Neway ADZ Product – Change Notification

Market Notification for Upcoming Neway Powered Vehicle Suspension Product Changes

Effective: April 2026

Neway ADZ 10" Cast Ductile Iron Frame Bracket

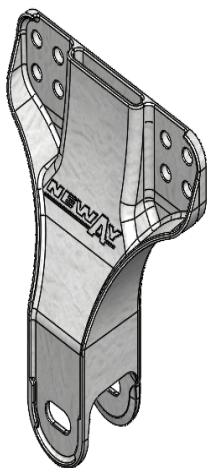
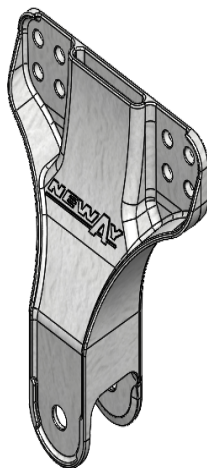
Beginning in April 2026, the Neway ADZ suspension with a 10-inch ride height frame brackets will feature a new cast ductile iron frame bracket, replacing the current cast steel design. The updated bracket will be available only in an adjustable configuration, eliminating the previous fixed and adjustable options. This change provides several key benefits:

Despite the material and design updates, the overall form, fit, and function of the new frame bracket remain equivalent to the original. The images below show the current frame bracket design on the left and the new ductile iron version on the right. If you have any questions or require additional product assistance, please contact your account manager or SAF-HOLLAND Customer Service at 1.800.876.3929.

- Commonality: The same bracket can now be used on either side of the vehicle.
- Simplified Inventory: Common hardware and fewer part numbers to manage.
- Enhanced Flexibility: Increased adjustment capability for easier installation and alignment.
